BODY ELECTRICAL

FUSE

169BE23

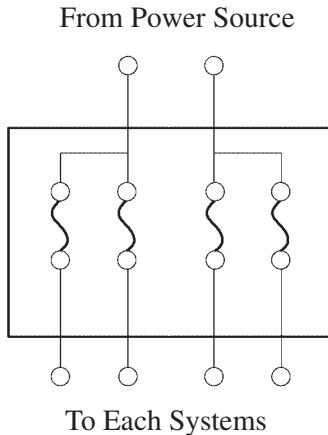
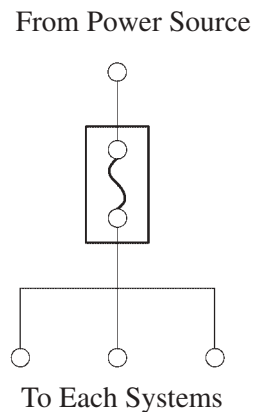
Because a single fuse was used on the previous model for supplying power to multiple systems, one blown fuse affected the operation of numerous systems. For this reason, the new model has adopted a multi-fuse system in which a single fuse housing contains four fuses. Four of these fuses are used in the junction block located in the vehicle interior.
